BCA ASSESSMENT REPORT

OAKDALE SOUTH ESTATE, HORSLEY PARK BUILDING 1D

Revision 2 Date: 15 April 2019 Project No.: 190034

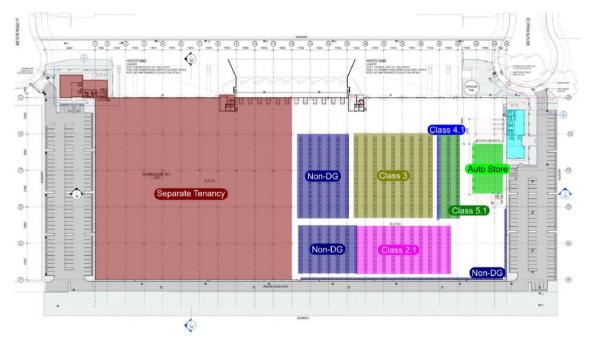
Note 1: It is understood that the proposed tenant in the northern tenancy (1D-2) is proposing to store Dangerous Goods within the warehouse area that exceed the SEPP 33 thresholds (as shown in the mark-up below) and a MOD Application is currently being lodged with the Department for this proposed change to the current approved use of the building

Figure 1 – Areas of Non-Compliant Perimeter Vehicular Access per BCA C2.4.

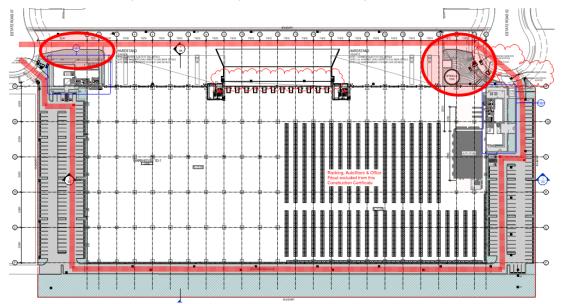
<u>Comments</u>: The proposed warehouse building does not comply with the provisions of C2.4 insofar as the vehicular access path is greater than 18m from the external wall of the building in the areas circled in red on the below mark-up. This non-compliance is required to be addressed as an alternative solution prepared

by the Fire Safety Engineer to demonstrate compliance with Performance Requirement CP9. Note: Any proposed Performance Solution will need to take into consideration that additional hazard that may result from the inclusion of Dangerous Goods Storage in the subject building.

Note 1: The road providing vehicular perimeter access must be designed with adequate loading capacities to withstand a fire truck and in accordance with NSWFB Policy No. 4: Guidelines for Emergency Vehicle Access.

Note 2: If the perimeter access path is reduced to less than 6m at any security gates it is required to be referenced in the above Performance Solution.
